**FIELD SERVICE BULLETIN**

FSB Number: LVCCFSB2004-22  
Author: Tony Bryan  
Date: March 4<sup>th</sup>, 2004  
Total No. of Pages: 3  
Subject: **GSM Triplets Rev. A PCB - ESD Improvement**  
Model Affected: GSM V300, V303, V400 (SUGxxxxAA)  
GSM V500, V525 (SUGxxxxAA or SUGxxxxBA)  
Level of Repair: 2

Diagram 1.0 New (0188940N02) Rev. E SIM Chassis Design

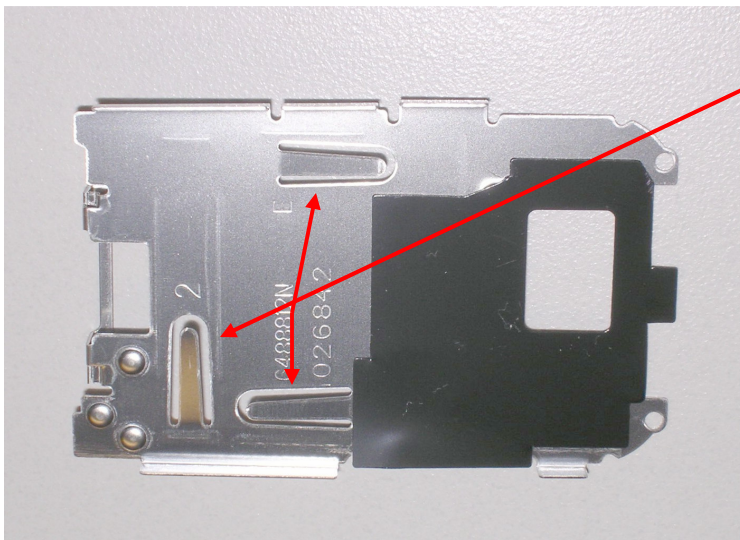
A re-design of the metal SIM Chassis (0188940N01) has been implemented in production as of 1/26/2004. The new (0188940N02) Rev. E design includes three metal fingers that extend into the housing and make contact with the PCB Shielding adequately grounding the SIM Chassis. For additional ESD Protection, a diode was added to the Rev. D PCB release.

**Special Note:**  
New Design with Three Metal Fingers to GND Chassis

Existing inventory of the original Rev. A Design (0188940N01) Sim Chassis should be removed and replaced with the improved (0188940N02) Rev. E Design.

Diagram 3.0 Battery Contacts

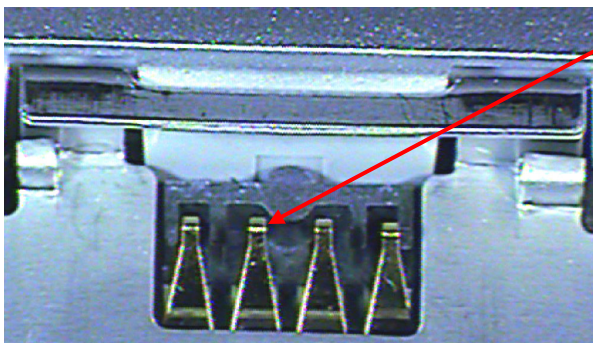
1. Power up the unit through the CE Connector with the battery removed
2. Probe the voltage on the OWB Line at M1700 (pin 3). The Voltage should be 2.7 VDC and will measure significantly less (approx 0.7 VDC) on failures with a damaged Neptune IC. See Diagram 2.0 below.

**OWB Line:**  
M1700 Pin 3 = 2.7VDC

- a. If the voltage on the OWB line is correct, then the fault is not related to this issue and normal troubleshooting techniques should be applied to the battery and the unit to determine the failed part.
3. Once a damaged Neptune IC has been confirmed the failed board should be swapped.
